APPROVAL <i>Slw</i>	REQUEST FOR COUNCIL ACTION	MEETING DATE 12/19/17
REPORTS & RECOMMENDATIONS	SPECIAL USE AMENDMENT TO ALLOW FOR BUILDING ARCHITECTURE ENHANCEMENTS AND IMPROVEMENTS TO THE PARKING LOT, SIDEWALKS AND LANDSCAPING FOR THE EXISTING DRIVE-THROUGH BANK PROPERTY APPROVED AS A SPECIAL USE IN ORDINANCE NO. 2002-1735, AN ORDINANCE TO AMEND ORDINANCES 92- 1229, 93-1261, 94-1298, 96-1391, 96-1400 AND 98-1508 CREATING PLANNED DEVELOPMENT DISTRICT NO. 16 (FRANKLIN CENTRE) (7745 WEST RAWSON AVENUE) (JOSEPH HAIDER, DESIGNER, LAMACCHIA GROUP, APPLICANT)	ITEM NUMBER <i>G.7</i>

REPORT TO THE PLAN COMMISSION

Unified Development Ordinance Text Amendment and Special Use Amendment

RE: Credit Union UDO Text Amendment and Special Use Amendment
Staff Comments

CONCEPT SITE PLAN

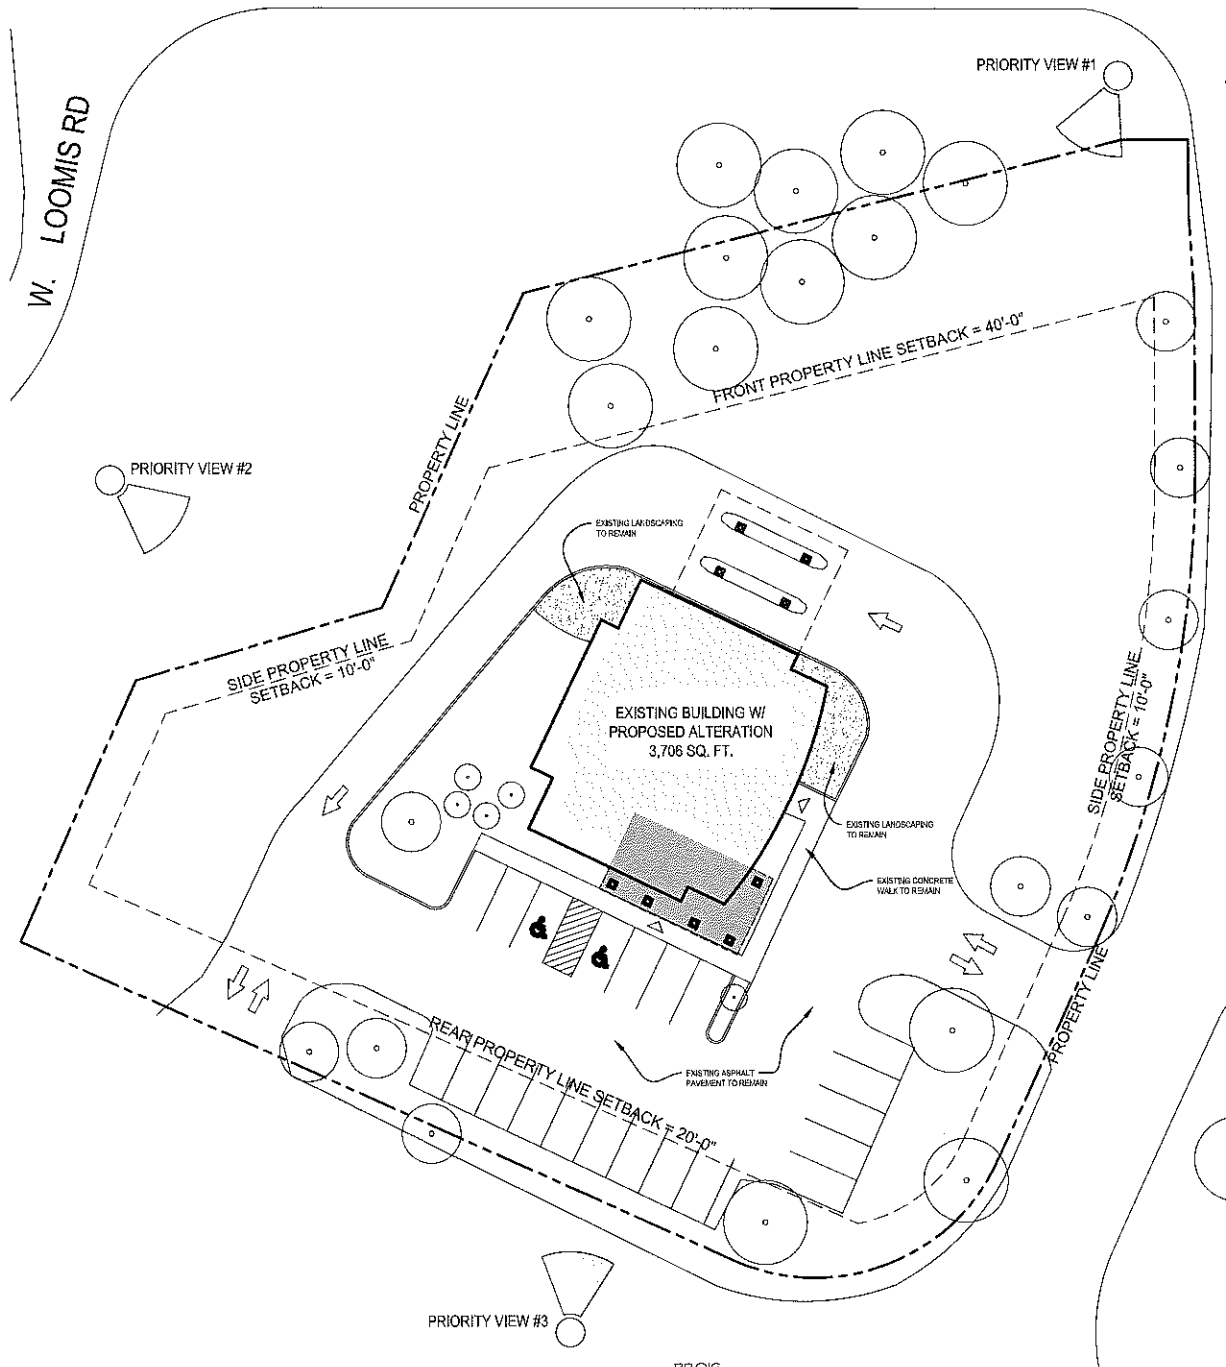
As a sidewalk is located on the east side of the entrance drive from/to Rawson Avenue (east of the subject property), but as only minor changes are proposed to the site, *staff suggests that a sidewalk connection from the building to the existing sidewalk be constructed.*

- b. Please revise the side and rear yard setbacks. Pursuant to Ordinance 2002-1735, Section 3H., the minimum setbacks are per the B-3 zoning district, which has a side yard setback of 10' and a rear yard setback of 20'. Please note that the parking lot setback is 10'. – Please see attached Architectural Site Plan for updates.

- a. Please note that Ordinance No. 2002-1735 requires a minimum vehicle queuing of 5 for each drive thru lane.
 - i. Staff believes that inadequate queuing is provided, and that such queuing is unsafe due to potential conflicts with the proposed additional parking. Therefore, staff recommends that the additional parking be removed or relocated.

- b. Please note that Ordinance No. 2002-1735, as well as the standards in Table 15-5.0203 of the UDO, only require 20 parking stalls. As proposed, 28 stalls, or 40% more than required, would be provided. Per Section 15-5.0203B.ii. of the UDO, detailed justification for this parking increase is required.

1. Staff suggests that a sidewalk connecting the building to the existing sidewalk to the east be constructed along with the parking lot changes. Should additional site changes be proposed now or in the future, staff would recommend the sidewalk connection at this time. - The client has chosen to eliminate the additional parking

4. Pursuant to Sections 15-7.0102C. and 15-7.0103S., please provide the Site Intensity and Capacity Calculations (please utilize the attached handout). – The client has chosen to eliminate the additional parking stalls from the project scope. Please see the attached updated Architectural Site Plan for reference.

10. Pursuant to Section 15-7.0103H., please provide additional details of the drive thru queuing lanes, and justification for the additional parking. - The client has chosen to eliminate the additional parking stalls from the project scope. Please see the attached updated Architectural Site Plan for reference.

Conceptual Elevations

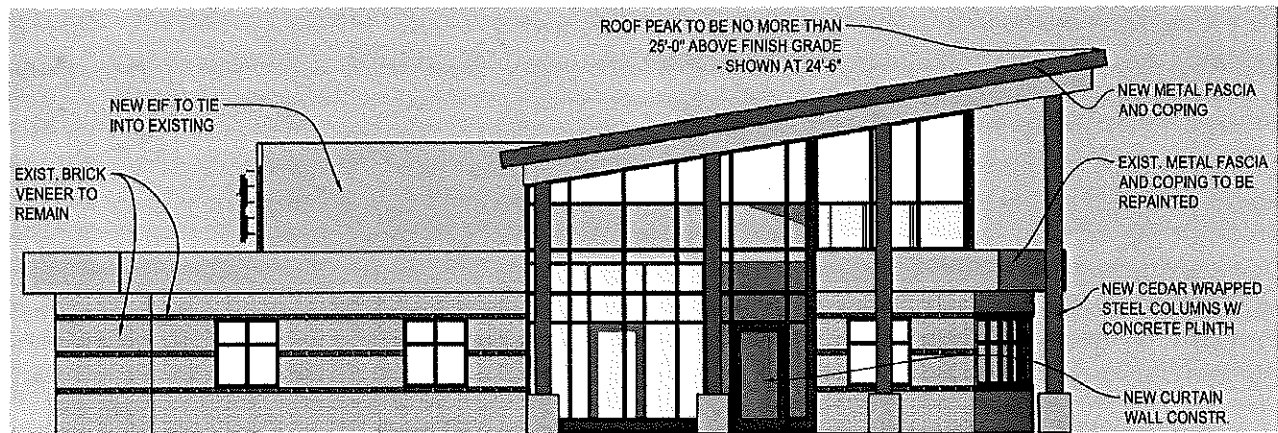
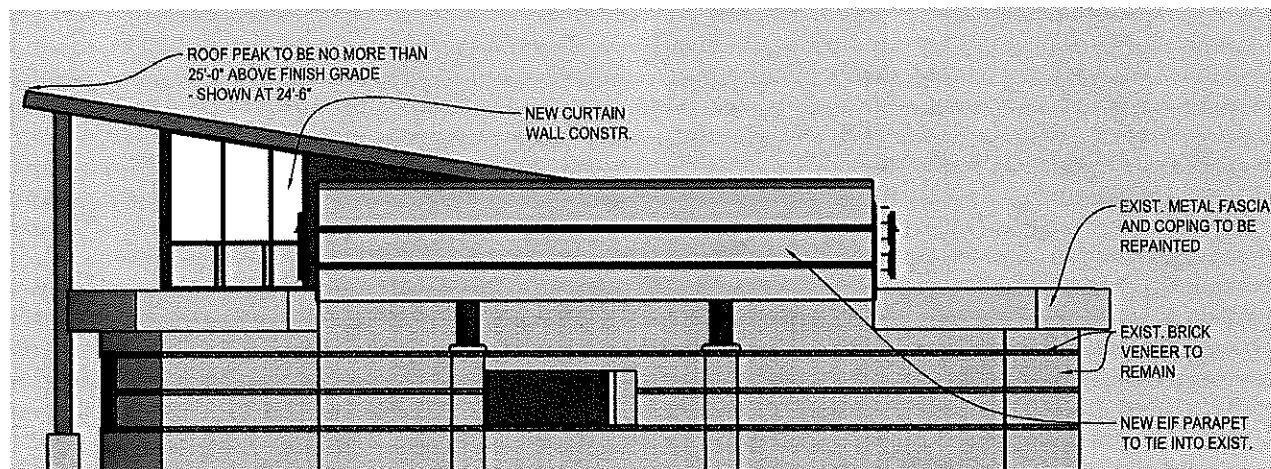
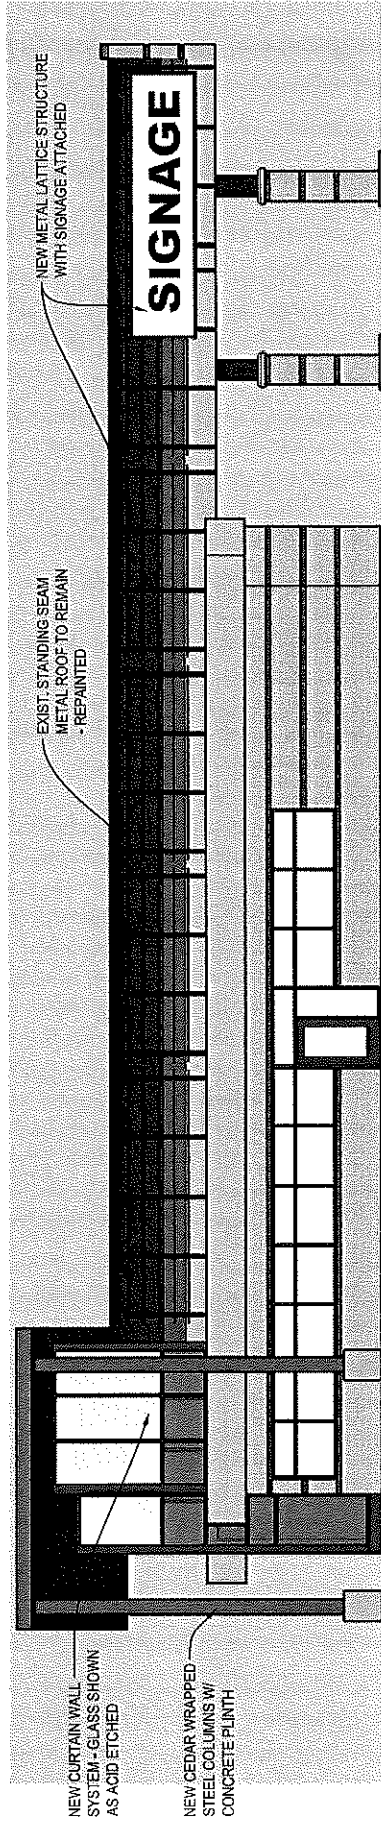
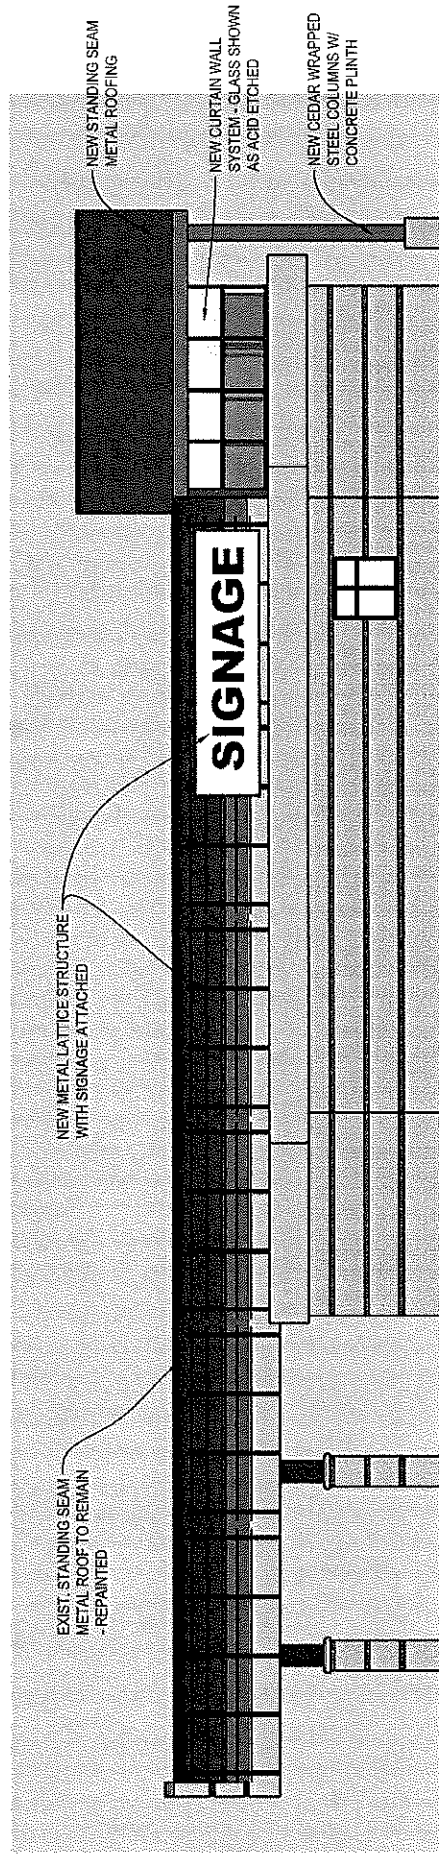
However, the applicant has not provided details about the new building materials and colors. Therefore, *staff recommends that the applicant shall prepare detailed architectural elevations for Department of City Development review and approval prior to issuance of a Building Permit.*

- c. Per Section 15-7.0103J. of the UDO, please verify the maximum height of the proposed building alterations. Staff recommends that detailed Building Elevations be provided depicting the height of the building, of the new entry feature, etc. – Please see attached Architectural Exterior Elevations for updates.

13. Pursuant to Section 15-7.0103V., staff recommends that more architectural details be provided, including the height of the various proposed building features, and the specific materials and colors associated with the building changes. - Please see attached Architectural Exterior Elevations for updates.

4. That the applicant shall prepare detailed architectural elevations for Department of City Development review and approval prior to issuance of a Building Permit.
5. That the applicant shall prepare a revised Landscape Plan meeting all UDO standards and re-establishing the PDD No. 16 approved landscaping as it applies to the subject parcel, for Department of City Development review and approval prior to issuance of a Building Permit, and that all required landscaping shall be installed prior to issuance of an Occupancy Permit.
6. That the applicant shall obtain review and approval by the Architectural Review Board for all new and revised signage, and obtain a Sign Permit from the Building Inspection Department for such signage, prior to its installation.
7. [other conditions, etc.]

SHEET TITLE
**ENLARGED
LANDSCAPE
PLAN**

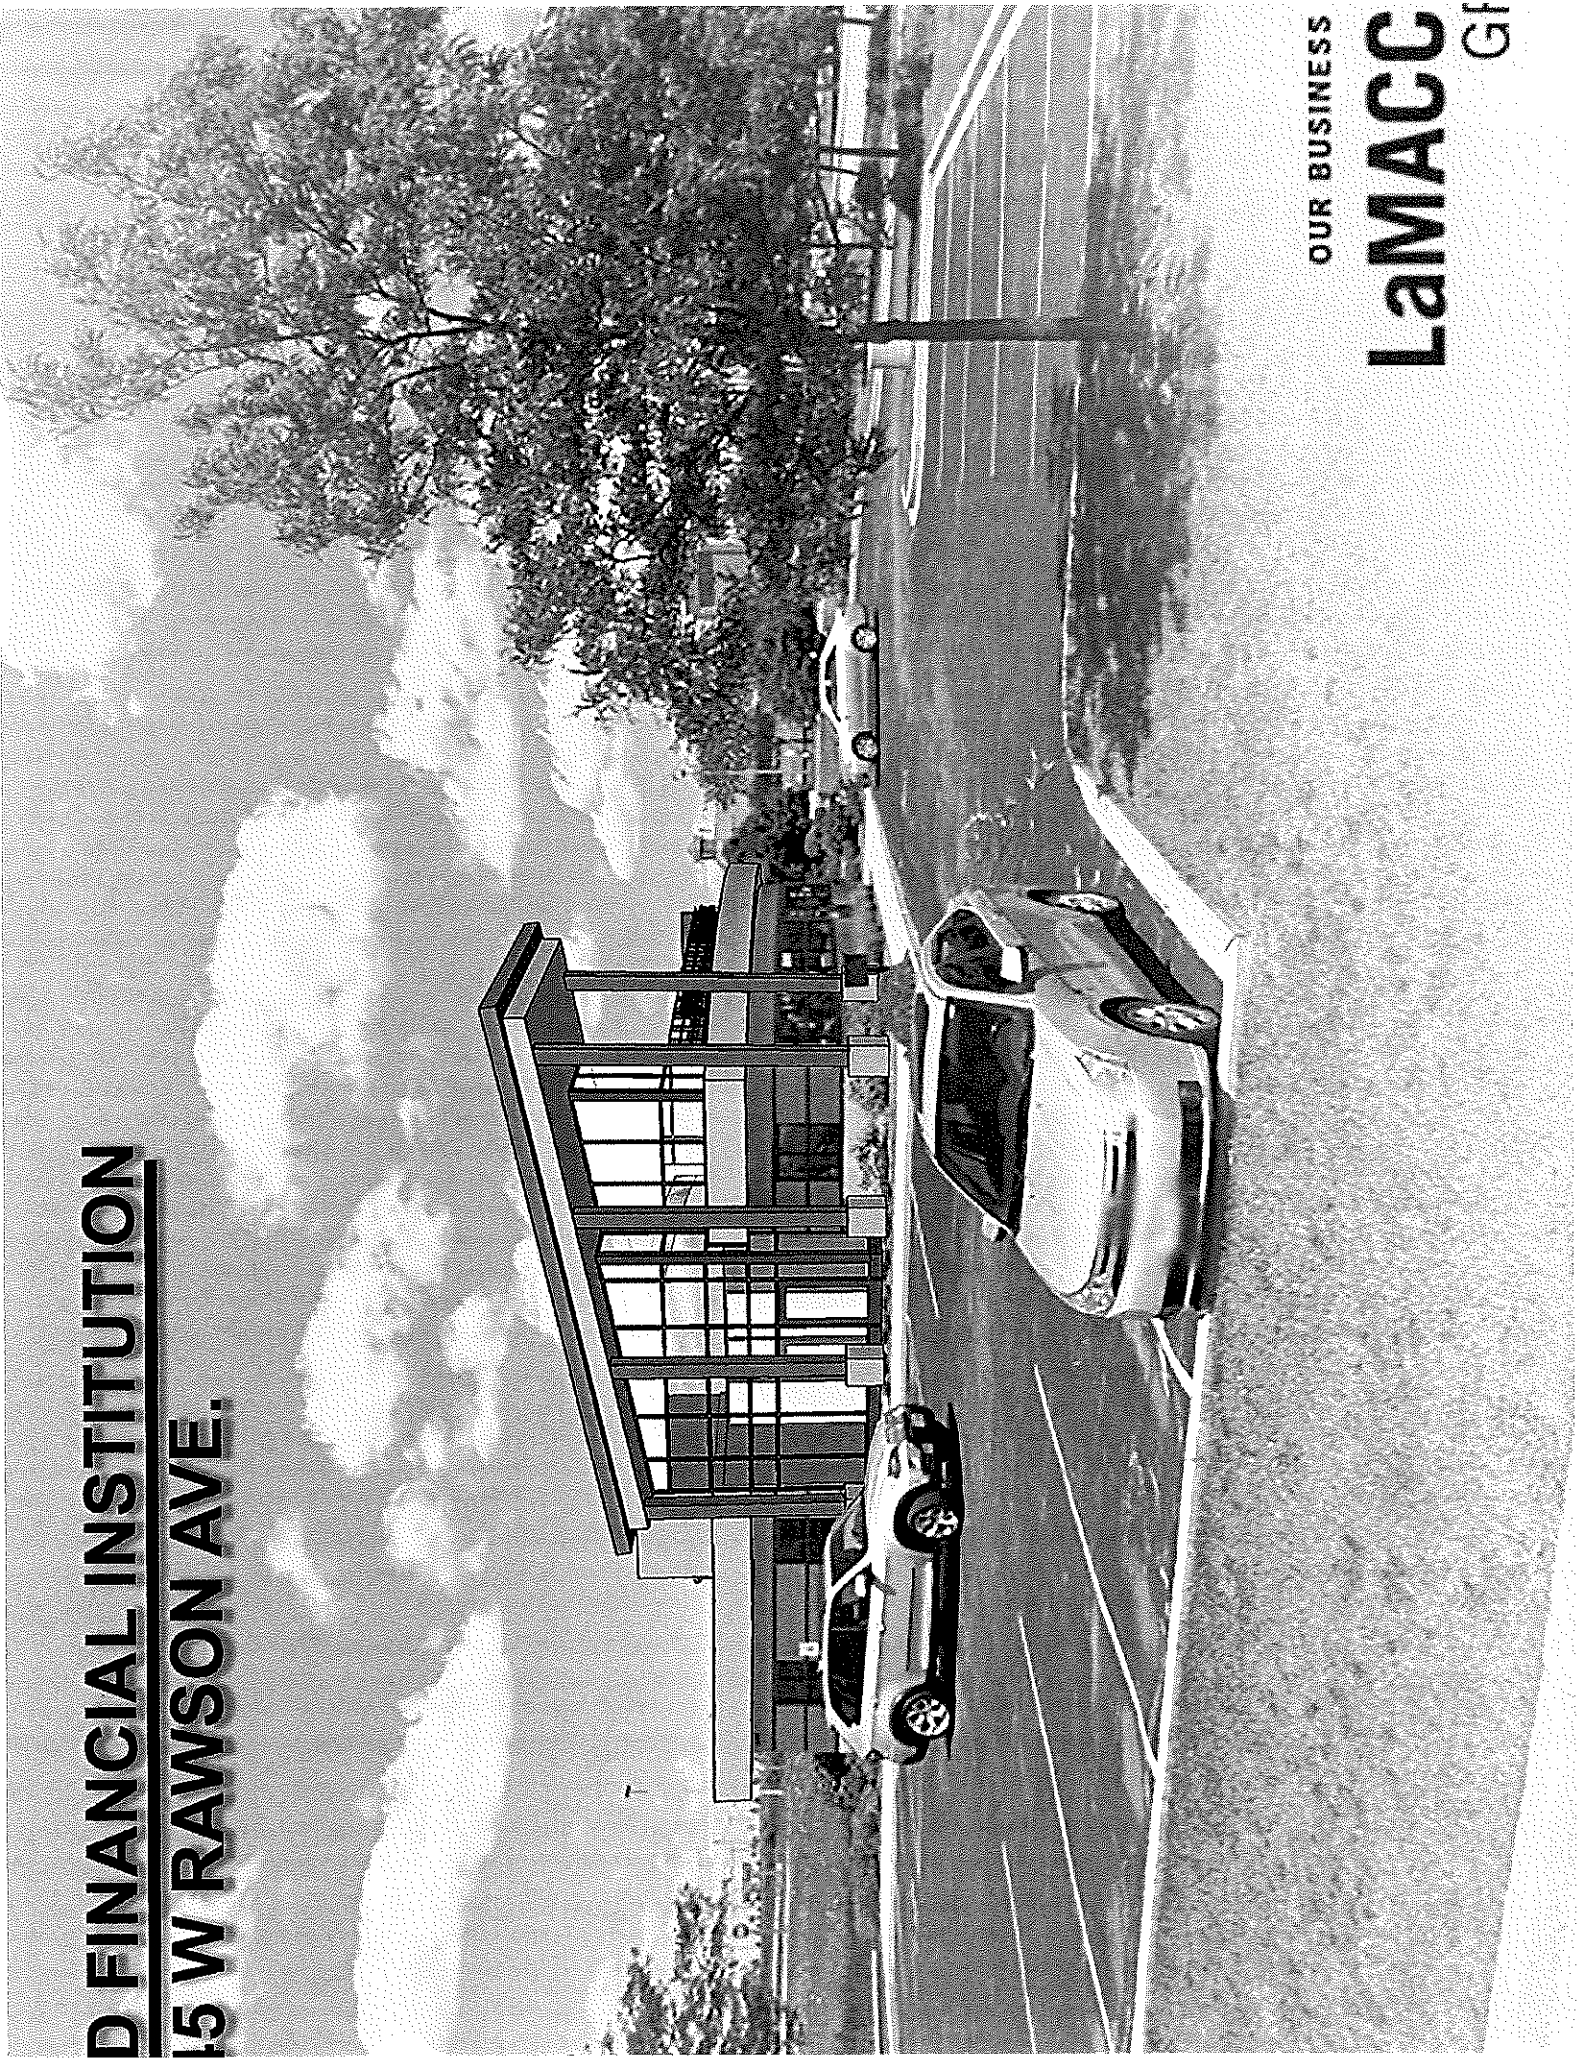
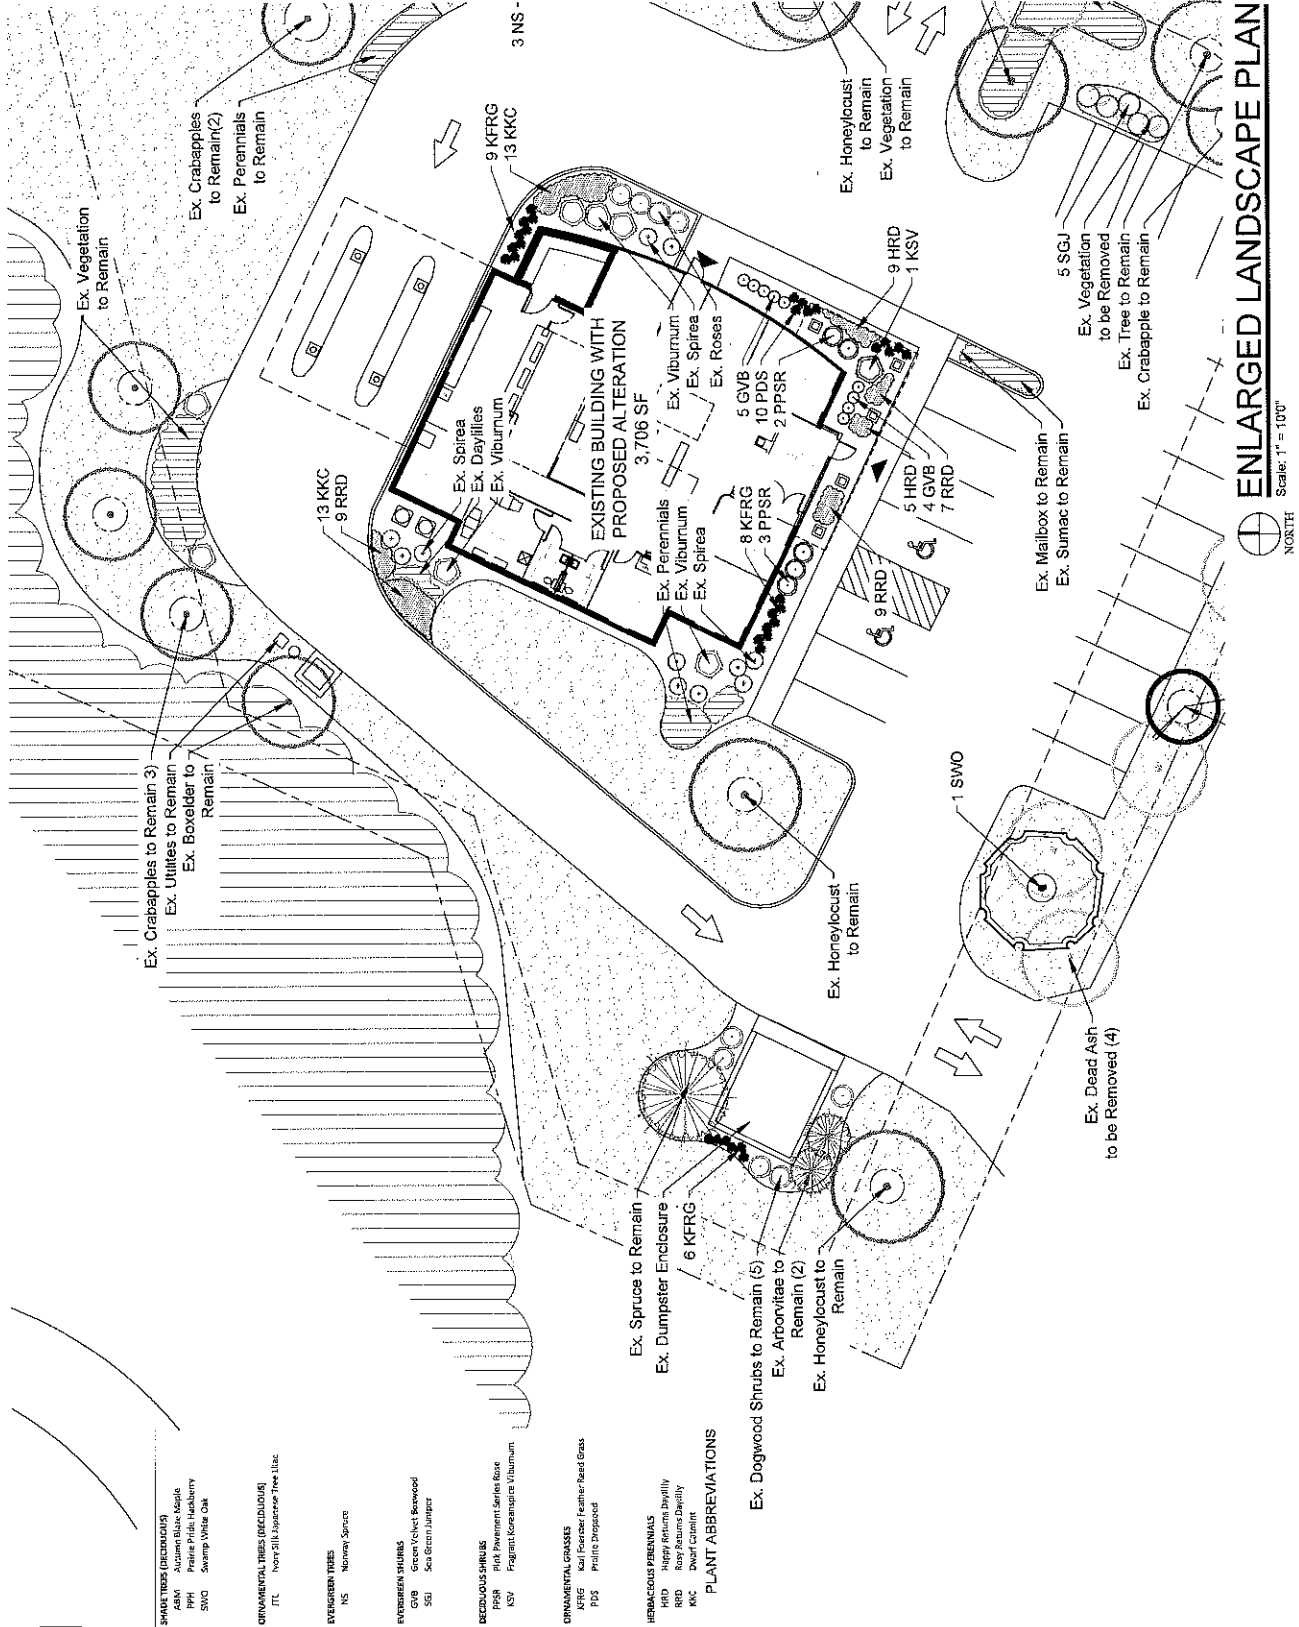
The applicant has submitted a Landscape Plan partially addressing the current UDO landscaping standards. However, it should also be noted that the 2002 Special Use approval for Anchor Bank included a landscape plan that provided slightly more landscaping than is required by the UDO standards. Furthermore, it can be noted that the original PDD No. 16 approval included a landscape plan for all of the entrance drives and parking lot perimeters, which partially extends unto the subject parcel. In regard to the portion of this landscaping on the subject parcel (comprising 15 trees), some have subsequently died, are dying, or are no longer present.

Staff recommends that the applicant shall prepare a revised Landscape Plan meeting all UDO standards and re-establishing the PDD No. 16 approved landscaping as it applies to the subject parcel, for Department of City Development review and approval prior to issuance of a Building Permit, and that all required landscaping shall be installed prior to issuance of an Occupancy Permit.

6. Pursuant to Sections 15-7.0102H. and 15-7.0103R., please provide a Landscape Plan. – Please see attached Landscaping Plan for reference.
 - a. Please note that staff does not object to re-establishment of the previously approved landscape plan for the Anchor Bank development dated 7-8-02, subject to replacement of the Ash Trees with some other native trees, verification that all originally proposed landscaping still exists and is healthy, and with additional landscaping added based upon any parking stalls added (per the standards set forth in Section 15-5.0300 of the UDO).

Alternatively, *staff would suggest that the applicant revise the landscape plan to re-establish the landscaping as set forth in the 2002 Special Use approval for Anchor Bank.*
